CODE	WIRING DIAGRAM AND CIRCUIT SCHEMATIC SAME AS FOR
558 CR & DR TYPE	558 DRW

LA-579162

CORDING

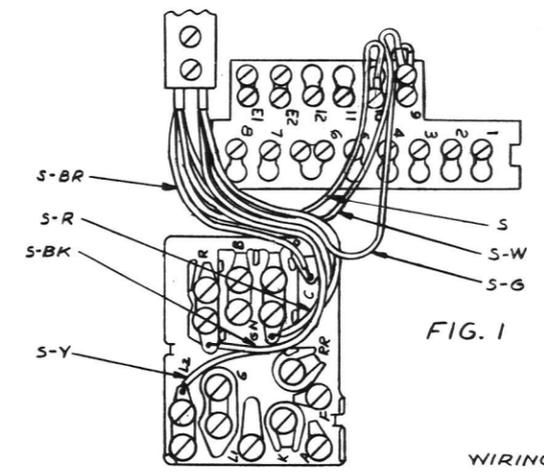
P.
 CHANGED: TERMINAL STRIP TO AGREE PICTORIALY WITH LP-11E256, 155.2.
 R.L.W. C.S. 643
 CO-2624/9 17M
 ISSUE: 2 5-25-59
 CHANGED: IN CORDING DIAGRAM, R-Y WAS G-Y; G-Y WAS R-Y; IN WIRING DIAGRAM, AT EXCLUSION KEY, R-Y WAS G-Y; G-Y WAS R-Y.
 JDM C.S. 643
 CO-441478 17M
 ISSUE: 3 12-23-59
 CHANGED: IN WIRING DIAGRAM, AT NETWORK, Y LEAD WAS CONNECTED TO LOWER SCREW AT TERMINAL G; CORDING TO AGREE WITH WIRING DIAGRAM.
 JDM C.S. 643
 CO-441528 17M
 ISSUE: 4 12-23-59
 CHANGED: VIEW IN SCHEMATIC WAS SHOWN THUS:

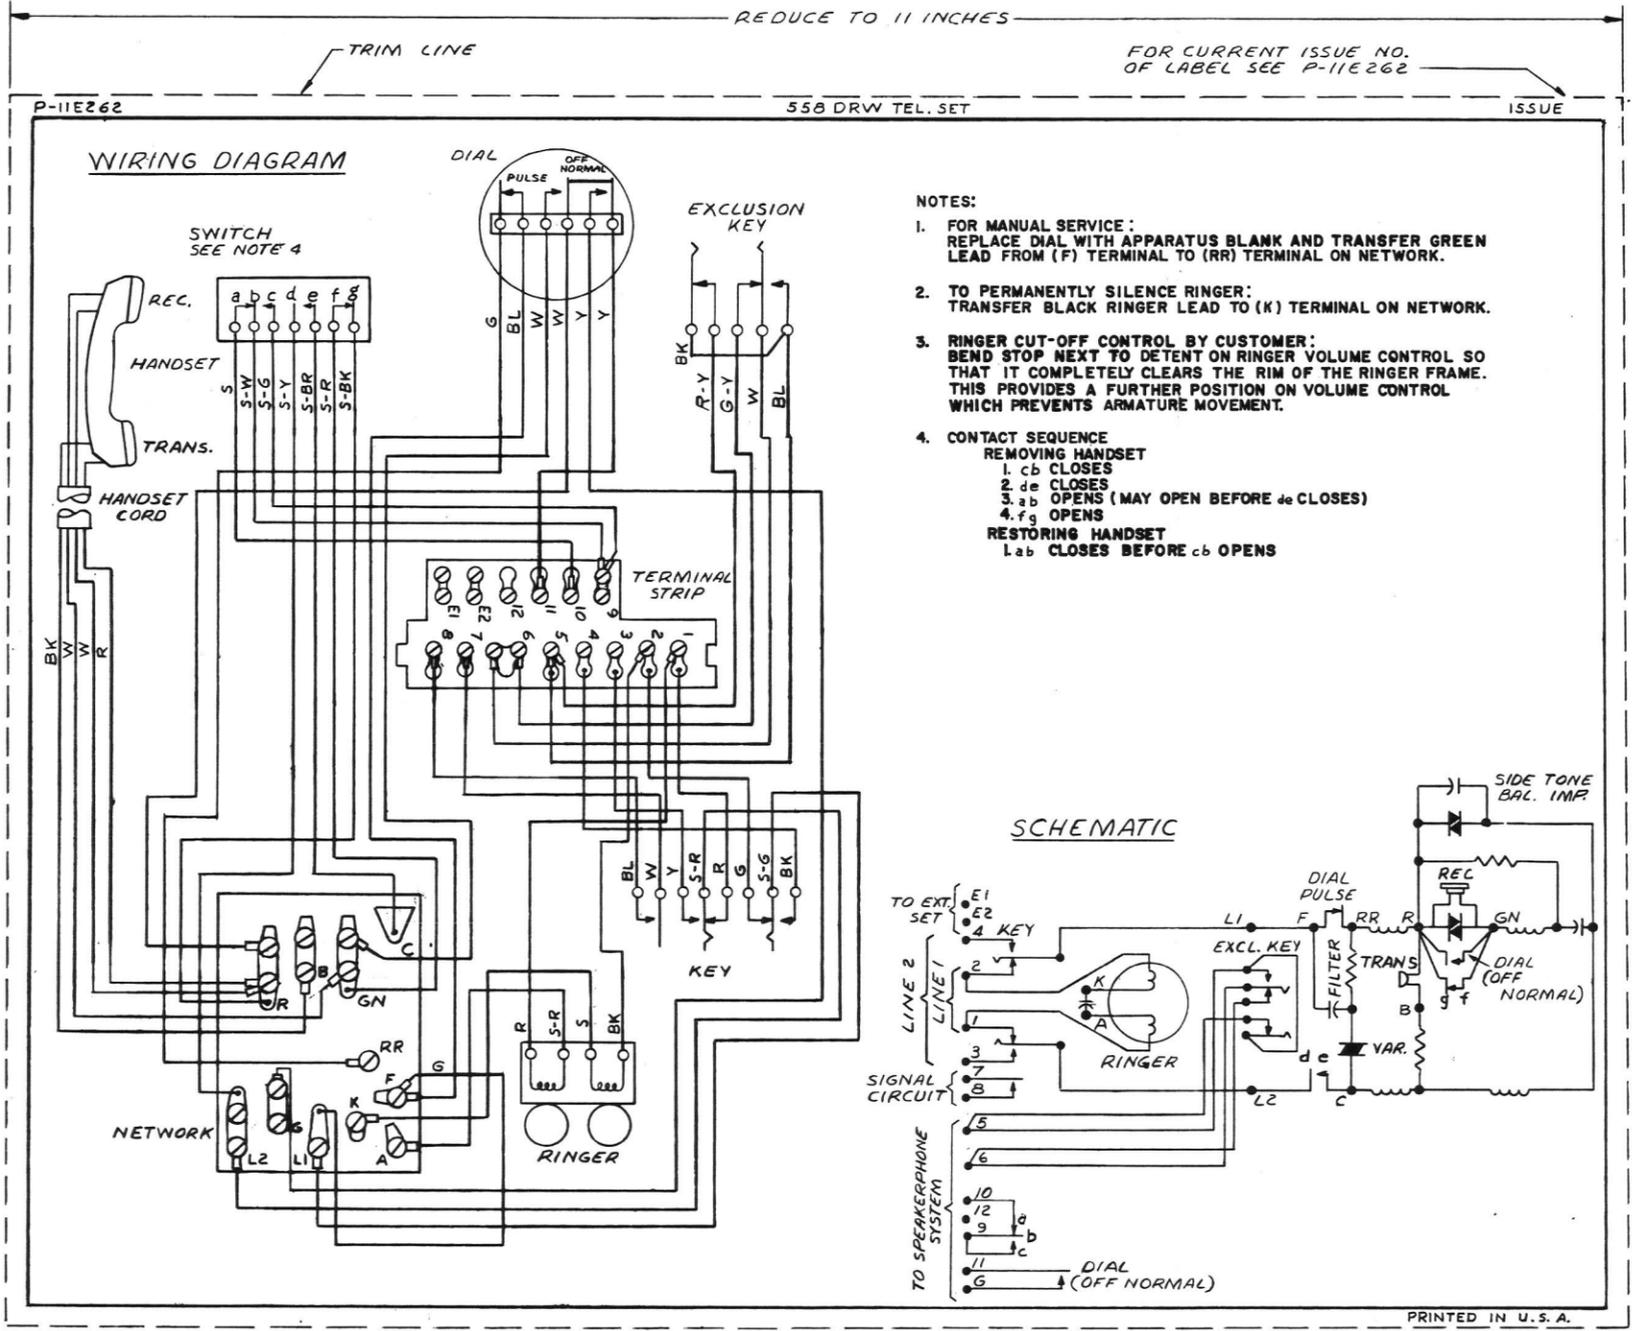
TO 659A XMTR. WIRING DIAGRAM AND CORDING TO AGREE.
 JDM C.S. 643
 CO-441537 17M
 ISSUE: 5 12-23-59
